SMA connectors

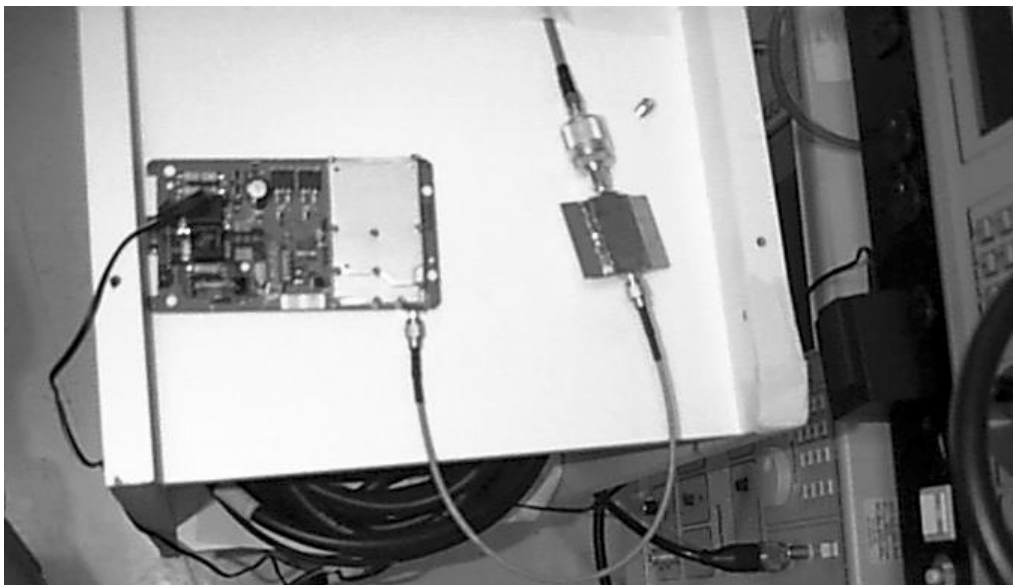
This addresses item #6 of your correspondence #8572
(Radiated measurements were also taken)

The SMA connectors pictured in the photographs of the connected measurement setup were used **only** to connect directly to the antenna connections on the PWB. The connector was soldered to the PWB and a cable was fitted to the PWB and HP 8595EM analyzer to take direct connected measurements. Cable loss was taken and added to the formula for correct measurement data.
